Technical Memorandum

PROJECT: 18-1-095

SUBJECT: **PEER REVIEW – PROPOSED P+M VINEYARDS, 1300 MT. VEEDER ROAD (ECPA P18-00001)**

FIGURE 6B
WATER LEVEL DATA DURING CONSTANT RATE PUMPING TEST
WELL A
PROPOSED P + M VINEYARDS PROPERTY

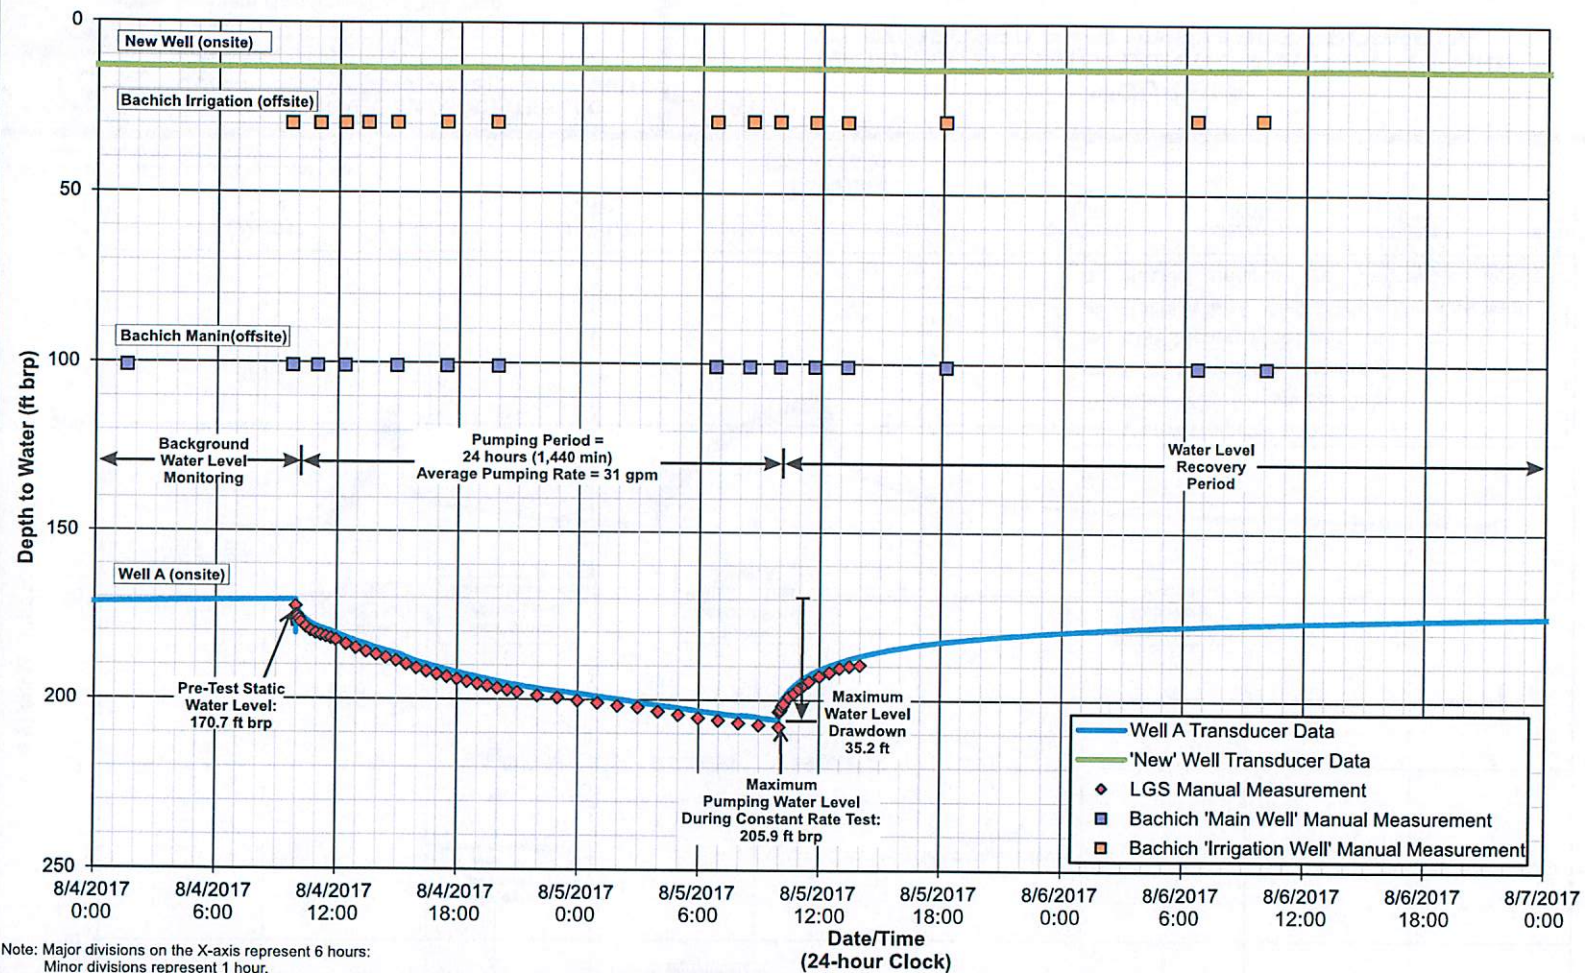
The Well A test protocol included a 9-hour step-drawdown test of up to 50 gpm and a 24-hour constant rate test at 30 gpm. The test protocol also included groundwater level monitoring at the New Well and the two offsite wells found to be within 500 feet of Well A, referred to as Bachich Main well and Bachich Irrigation well. Groundwater level monitoring occurred for approximately four days at the New Well and Well A following the 24-hour constant rate test at Well A, that began on August 4, 2017. Groundwater level monitoring occurred for one day at the Bachich Irrigation well and for approximately two days at the Bachich Main well, following the 24-hour constant rate test at Well A. Groundwater level data reported in the Draft WAA show no groundwater level declines observed at the New Well and Bachich Irrigation well. A groundwater level decline totaling 0.02 feet (ft) was recorded in the Bachich Main well during the 24 hours when Well A was pumping and an additional 0.04 ft, 20 hours after the pump in Well A was turned off. **Table 2** summarizes results of the two aquifer tests reported in the Draft WAA.

Following the 24-hour constant rate test, water level recovery in Well A was 82% after one day and 99% after four days. These rates of water level recovery are similar to rates observed during aquifer tests performed at Woolls Ranch in 2014.

FIGURE 7A
CONSTANT RATE PUMPING TEST ANALYSIS
THEIS/HANTUSH CONFINED AQUIFER SOLUTION
WELL A (PUMPING WELL)

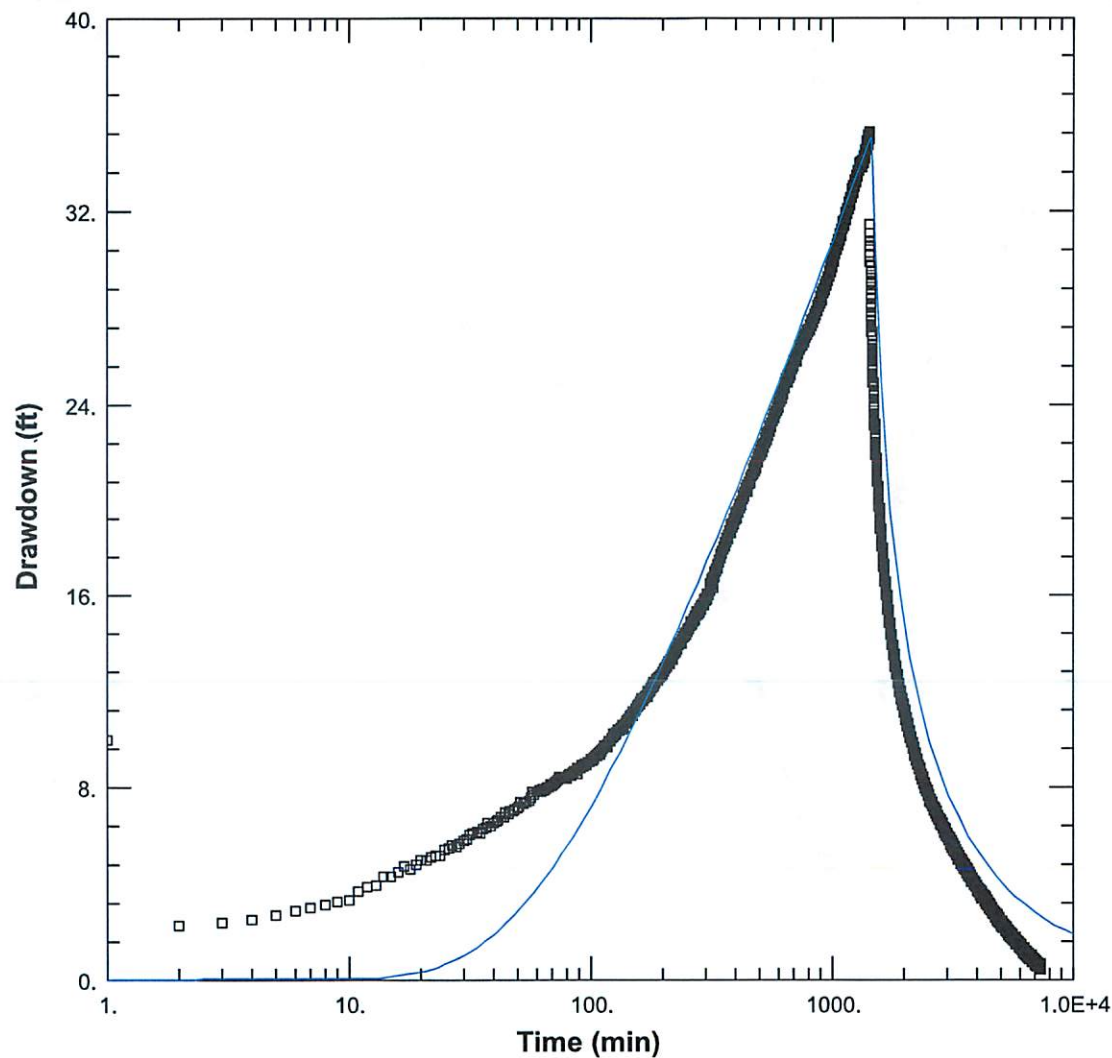
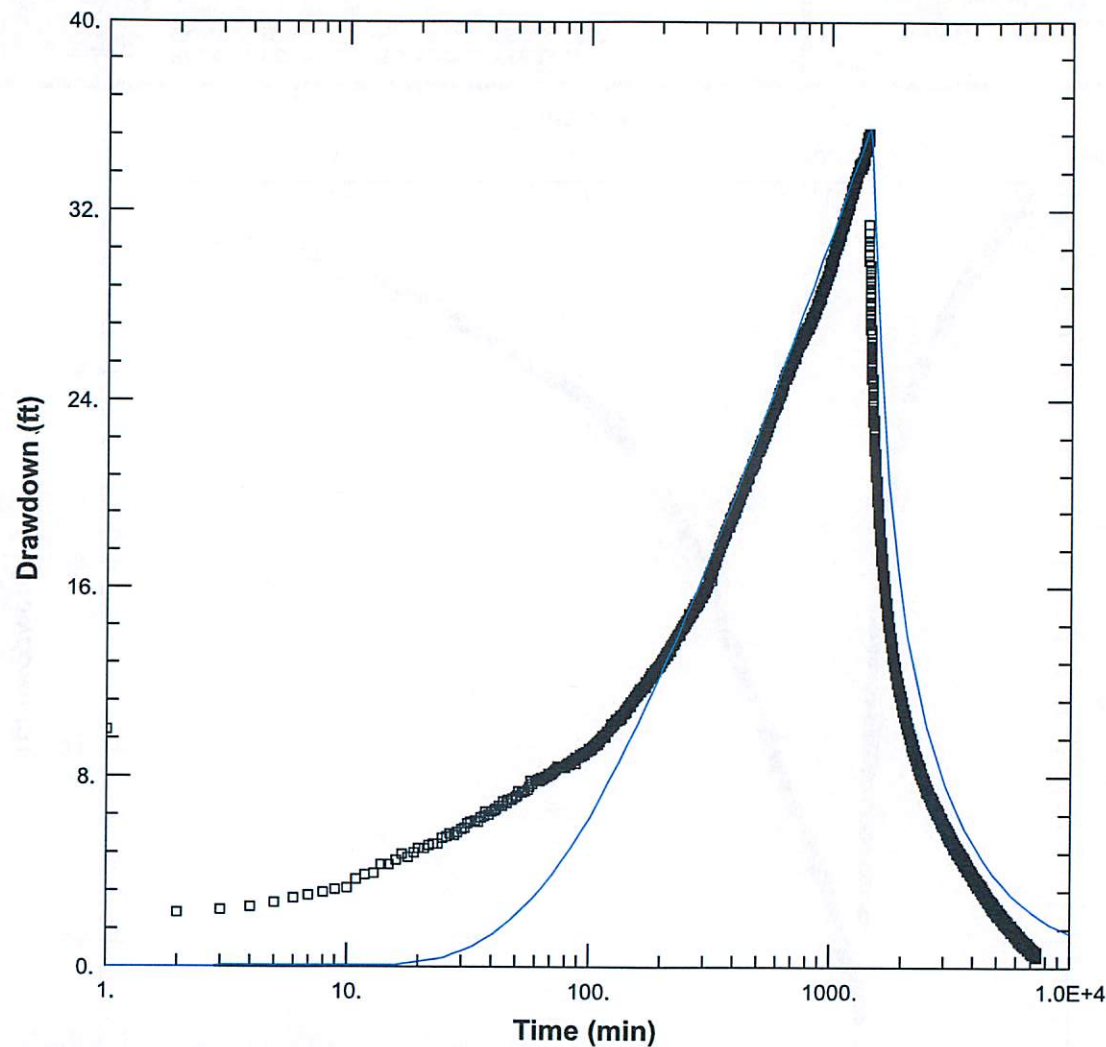
The transmissivity values of 291 and 260 gallons per day per foot of drawdown (GPD/ft) are low, though, comparable to values from aquifer tests of wells completed in the Great Valley formation in the area. RCS also applied an empirical equation to calculate transmissivity based on the general relationship between discharge and drawdown at the pumped well and aquifer transmissivity. RCS found the empirical equation produces a transmissivity result of 1,540 GPD/ft, which is noted to more likely reflect conditions near to the well rather than the more regional conditions represented by lower transmissivity values calculated based on curve-matching to analytical solutions.

**Table 3. Comparison of Aquifer August 2017 Test Results,
P+M Vineyards ECPA (P18-00001)**

Well	Pump/ Observation	Analysis Method	Transmissivity (GPD/ft)
Well A	Pumped Well	Theis/Hantush Confined Aquifer Solution Drawdown and Recovery curve-fitting	291
Well A	Pumped Well	Hantush/Jacob Leaky Aquifer Solution Drawdown and Recovery curve-fitting	260
